Response to Submissions
Modification of Ulan Coal - Continued
Operations
North 1 Underground Mining Area,
Minor Modifications to Ulan No.3 and
Ulan West Mine Plans and Proposed
Concrete Batching Plant

Prepared by
Umwelt (Australia) Pty Limited
on behalf of
Ulan Coal Mines Limited

Project Director:	Barbara Crossley		
Project Manager:	Phillip Weir		
Report No.	2879/R04/Final	Date:	September 2011

Existing Catchment Boundaries and
location of Reece Robinson Property

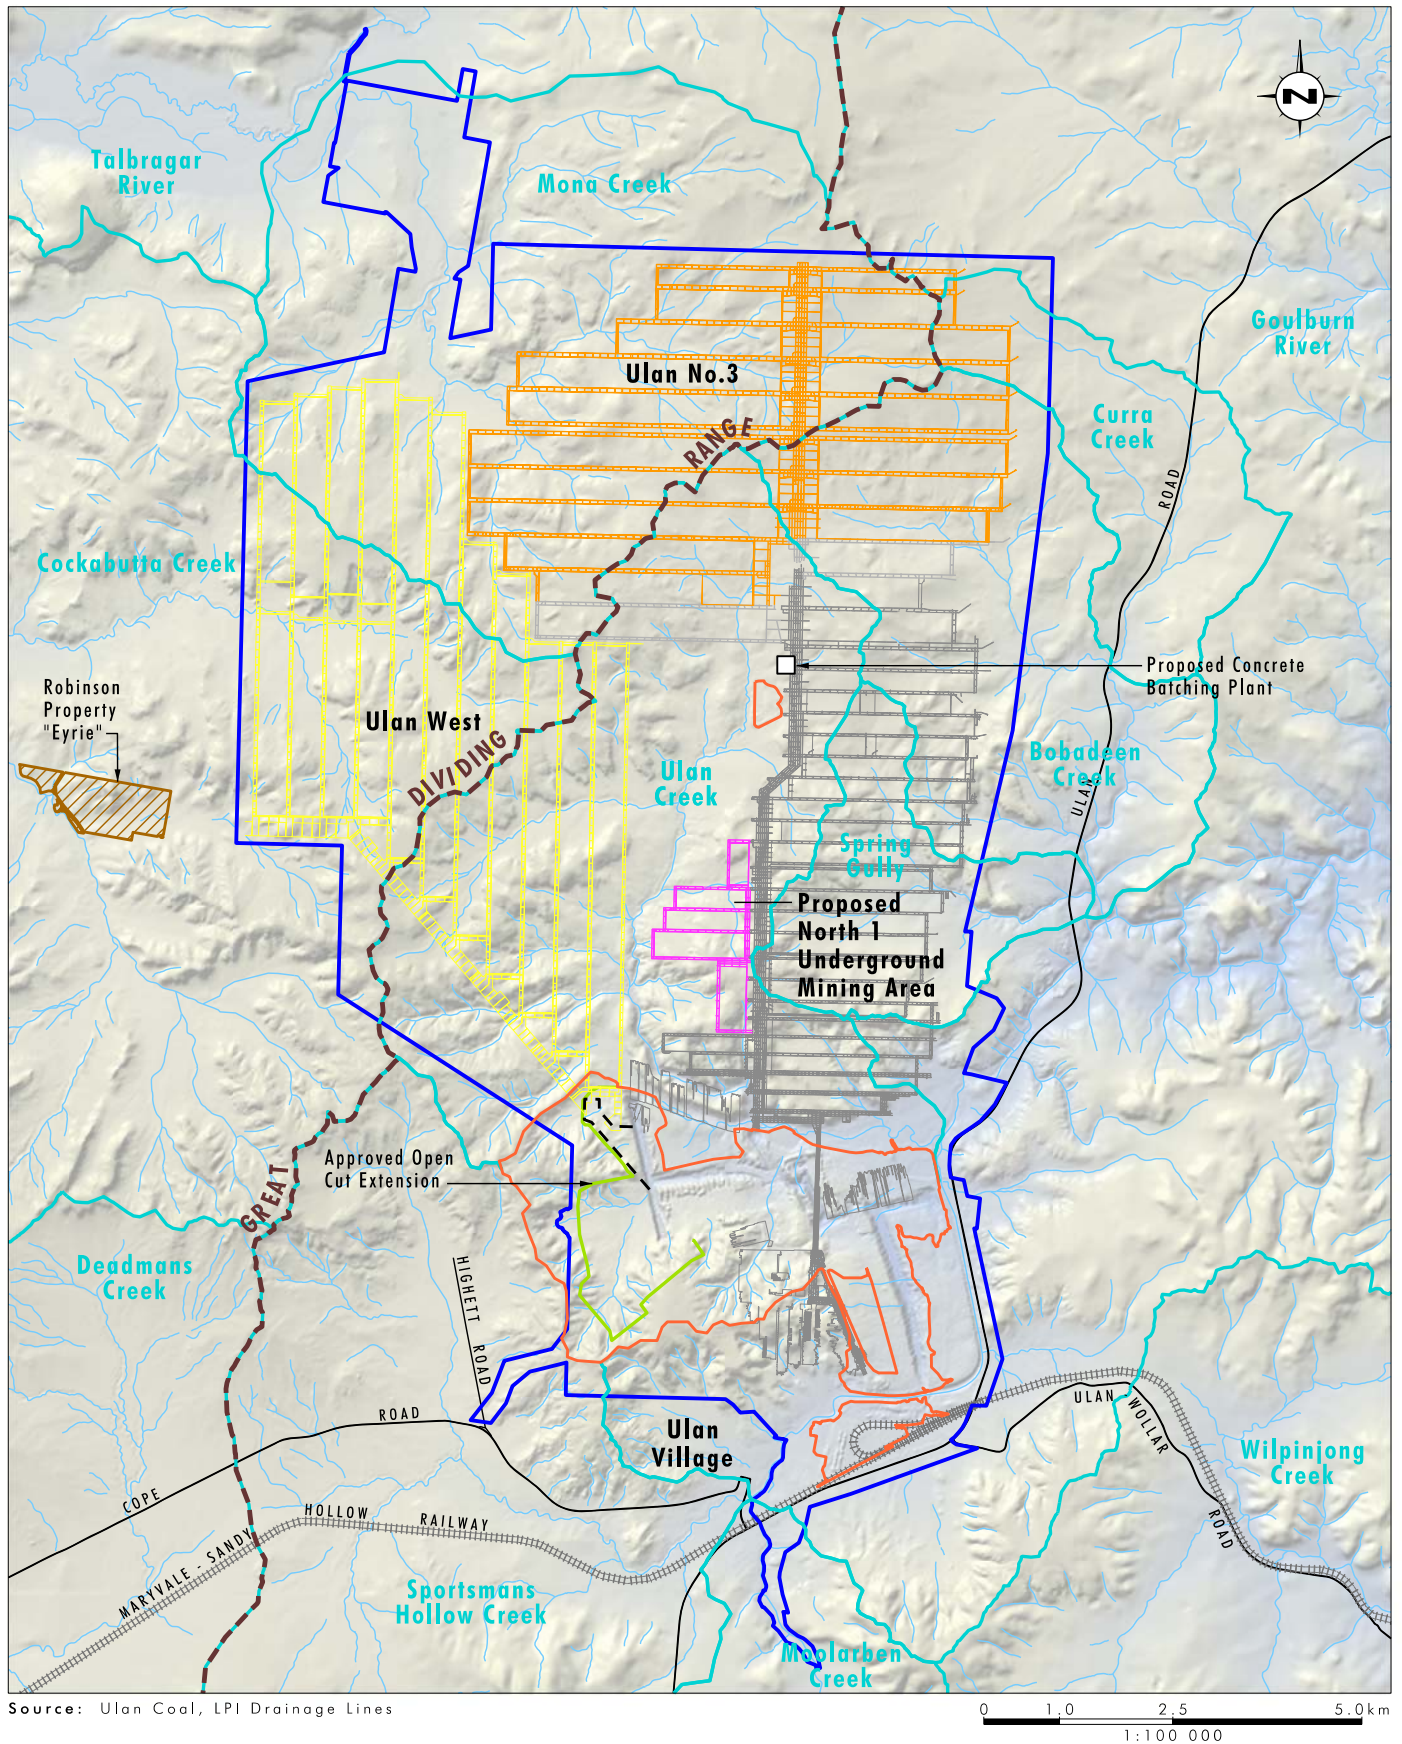
Groundwater Depressurisation	
	The landowner is concerned that depressurisation of groundwater will impact upon a spring which is located south of the Ulan West 9, 10 and 11 long walls and supplies surface water to the area.	See Section 3.3.2

Respondent	Issue Raised	Response and Relevant Section in this Report
	The EA has focussed groundwater impacts on stream catchments to the north and east of the Mr Robinson's property.	See Section 3.3.2
	Figure 6.3 (Attachment 2) of the EA shows the location of the monitoring bores and notably the monitoring bores are not located within the headwaters of the streams within the valley where Mr Robinson's property is located. The submission requests that there be adequate assessment of the likely impacts of the mining on the groundwater springs that feed the water courses that cross Mr Robinson's property.	See Section 3.3.2
	Surface Water	
	The focus of the assessment on surface water does not address the impacts within the surface watercourses within Mr Robinson's property.	See Section 3.3.2
	The focus of the assessment has been on surface water impacts within the mine site and the major adjoining watercourses but not on the lower order tributaries in particular those which are spring fed.	See Section 3.3.2

The proponent acknowledges in Section 6.3.1 of the EA that minor changes are proposed for the Cockabutta Creek Catchment Area, but no further detail or assessment is provided.	See Section 3.3.2
	Threatened Species and EPBC Act	
	The EA assumes that the impacts to be assessed relate only to the modifications with limited discussion regarding the cumulative impacts. The assessment should focus on impacts on particular locations, in particular those immediately adjacent to the Ulan West operations such as Mr Robinson's property.	See Section 3.2
	The previous assessments have focused primarily on the impacts of the specific works in the particular approvals rather than the impacts of the mine operations as a whole. Through adopting this approach it is possible for the proponent to say at each step that the works being undertaken do not have a significant impact on threatened species either for the purposes of the New South Wales legislation or the Commonwealth legislation and to not adequately address the impact of the project as a whole.	See Section 3.2

As shown in **Figure 1**, the Robinson property is located in the upper reaches of the Cockabutta Creek catchment. Cockabutta Creek is a second order stream within the subsidence affectation area and flows through the western section of the project area in a westerly direction to the Talbragar River catchment area (refer to **Figure 1**).

No direct surface water impacts due to subsidence are predicted to occur on Mr Robinson's property as the subsidence impacts from underground mining at UCML are predicted to be contained within the mine lease and Mr Robinson's nearest property boundary being located approximately one kilometre to the west and downstream of the UCML's approved colliery holding boundary (Umwelt 2009).

No indirect impacts on Mr Robinson's property are predicted to occur as a result of the subsidence upstream of his property, as there will be negligible change to the Cockabutta Creek catchment boundary in the subsidence affectation area, and detailed hydrology analysis has confirmed that the predicted subsidence impacts will not result in any substantial ponding or drainage realignment within the project area (Umwelt 2009). Further, detailed modelling of landforms, pre and post subsidence, have confirmed that the stream velocities will not be significantly impacted, and thereby there should not be any substantial erosion affects in the subsidence area and therefore downstream water quality will be maintained. That is, there is not expected to be any impact on availability or quality of surface water flow at Mr Robinson's property downstream of the mining area.
